**GPT/BNSF Custer Spur EIS Co-Lead Agencies c/o CH2MHill**

**Subject: Draft EIS Scoping Comments related to rail access and bulk coal storage**

ALTERNATE B

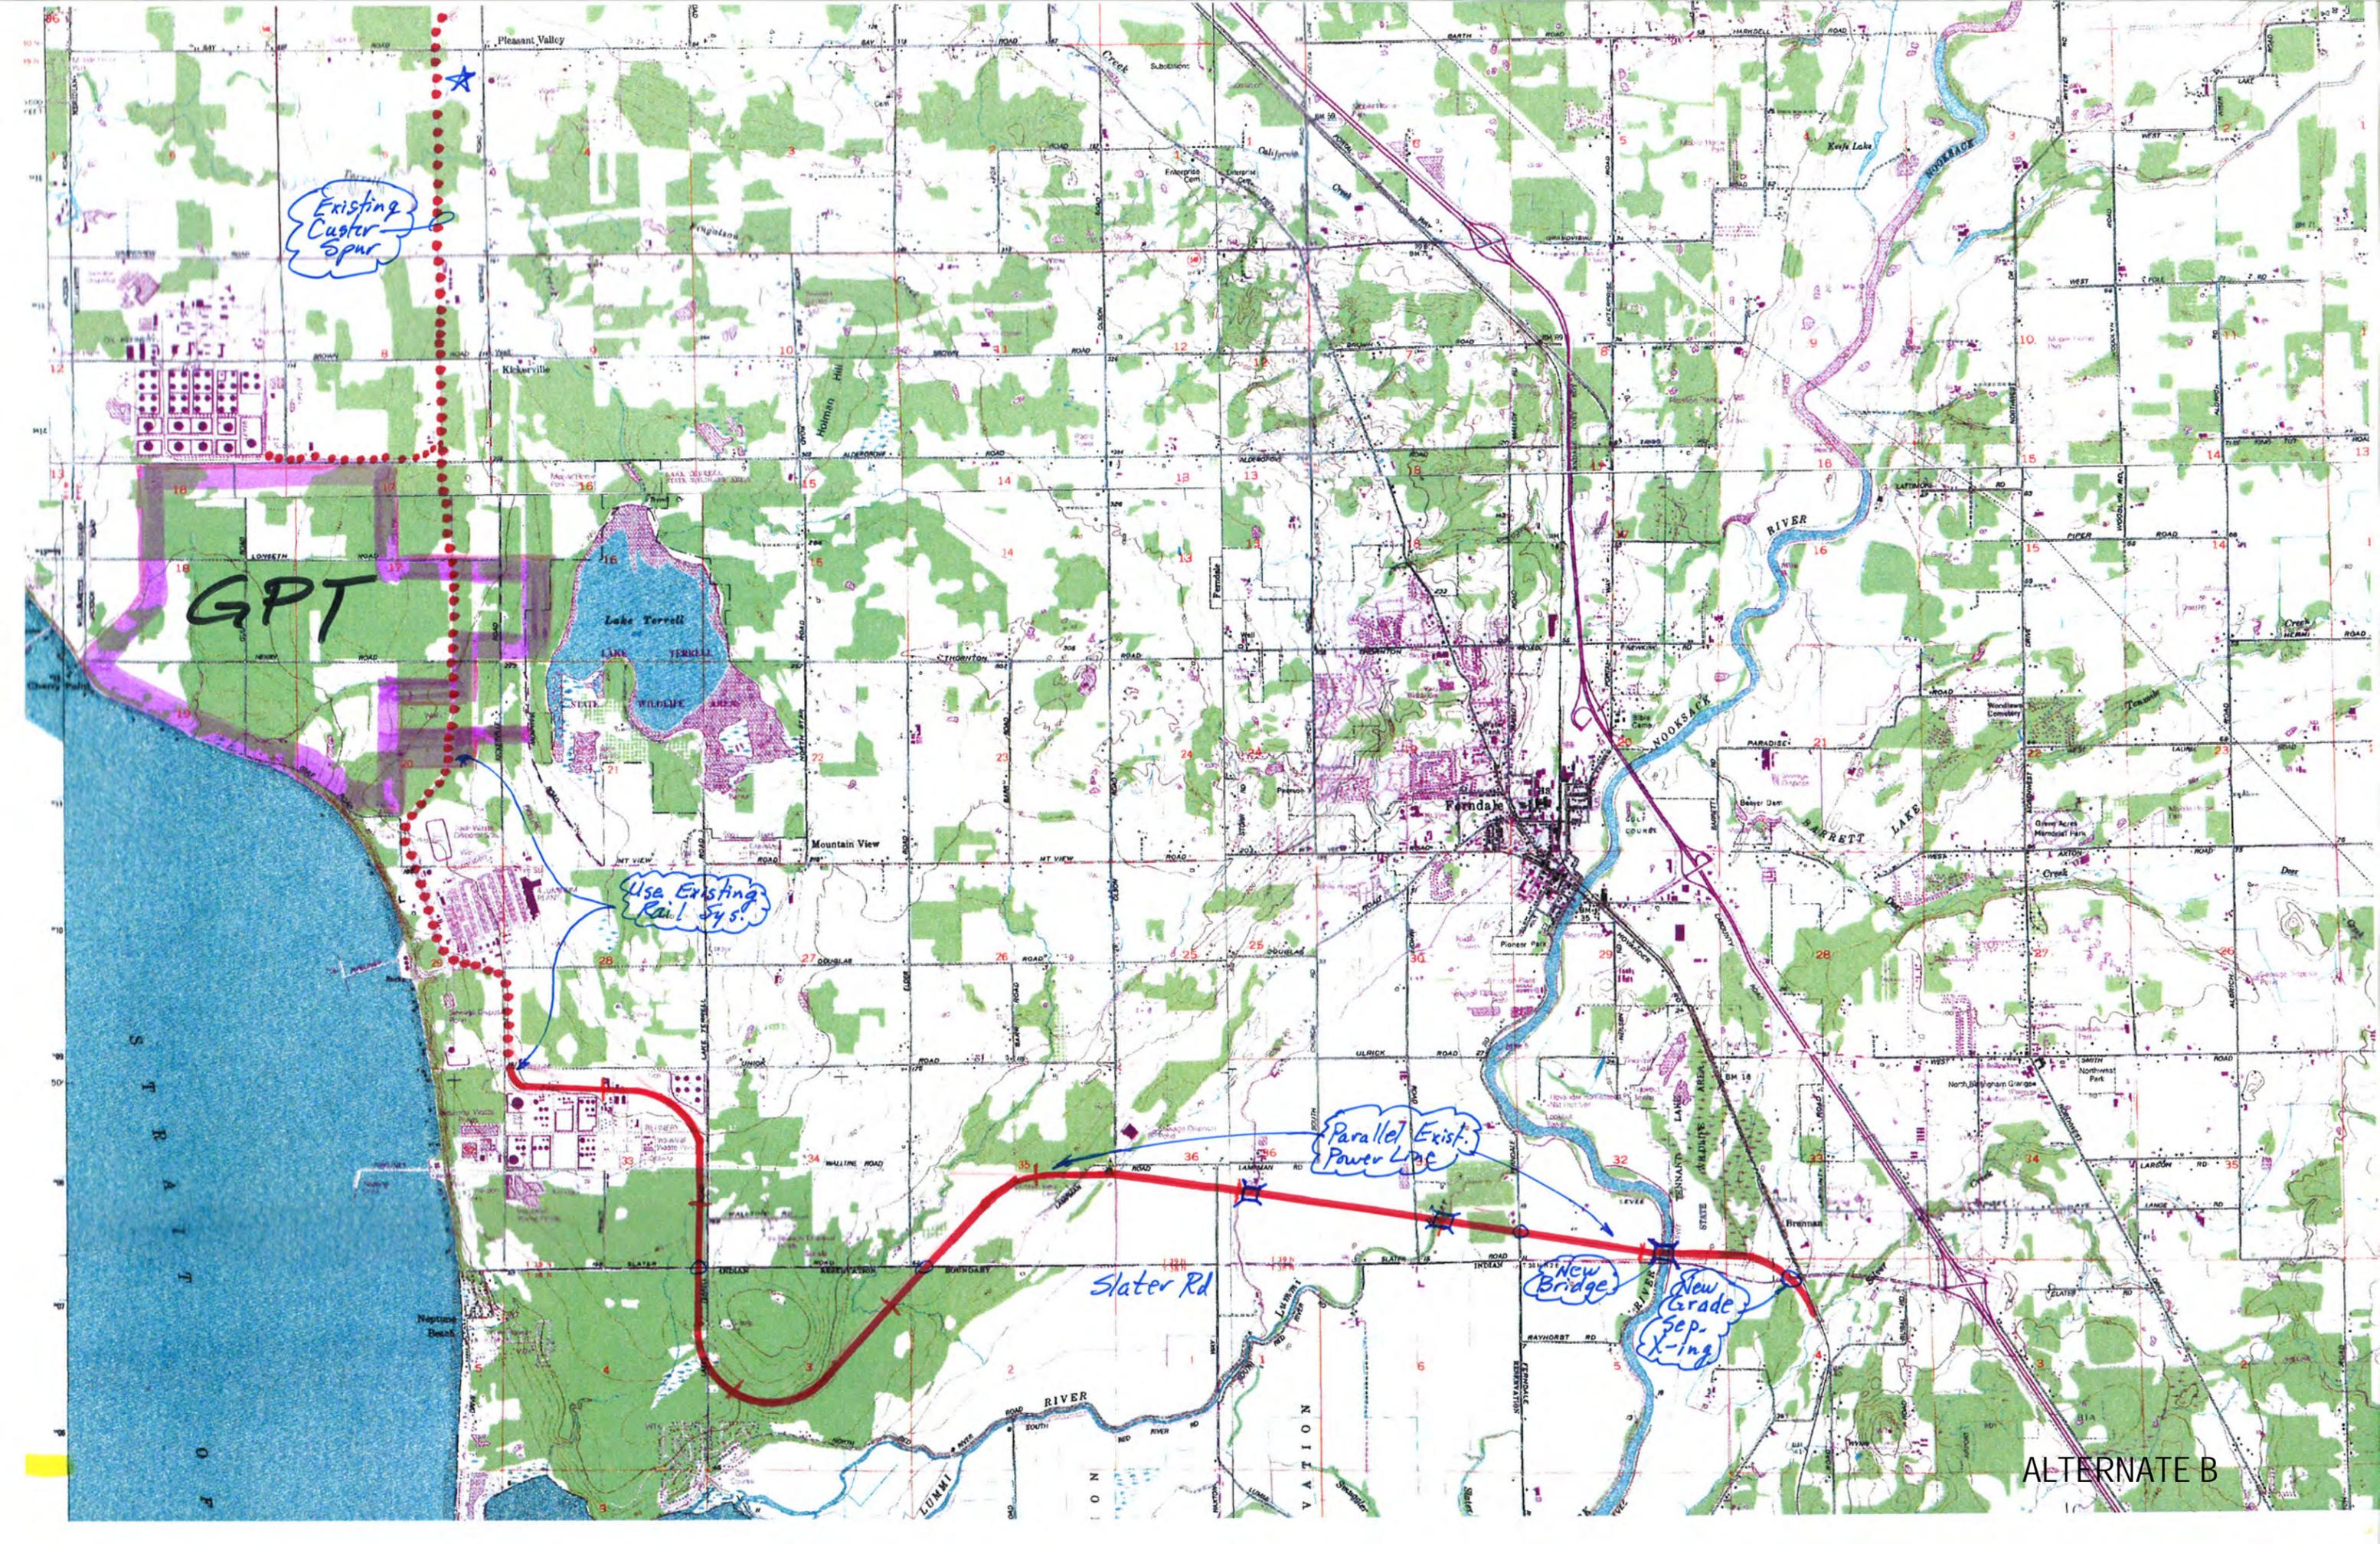
*The Draft EIS should include alternative rail access routes in lieu of the Custer Spur improvements. Although the Custer spur provides the convenience of an existing BNSF right-of-way it also has numerous shortcomings. A better rail access route would consist of a new rail spur following a corridor generally along Slater Road. The following is a summary of the advantages of a new rail spur instead of using the Custer spur;*

- 1. A Slater Rd. rail spur alignment is only 8 miles in length (from Slater Rd and I-5) to GPT) whereas the Custer spur route is approximately 16 miles. The new rail spur could be constructed at grades consistent with modern railroad design standards. For example the new rail spur could parallel an existing high voltage power line located just north of Slater Rd. that goes through essentially open agricultural fields for more than 3 miles. **(Alternate A)** Then at Lampman road there could be a grade cut to minimize the grade change, after 1.5+/- miles continuing to follow the power easement the track could turn 40 degrees +/- to the north crossing Lake Terrell Road on to CONOCO property and aligning with the existing track. **(Alternate B)** Then west of Elder Rd. it could swing to the south of Slater Rd. through undeveloped/forested land (Lummi Reservation) as it ascends the grade. Upon reaching Lake*

*Terrell Rd. the alignment could go north through the refinery site and connect with the existing rail line near Unick Rd.*

*The Slater Rd. rail spur would impact fewer existing residential properties, have far fewer at grade road crossings and other advantages as described in the following items. Refer to the attached Exhibit A & B illustrating similar proposed rail spur routes along the Slater Rd corridor.*
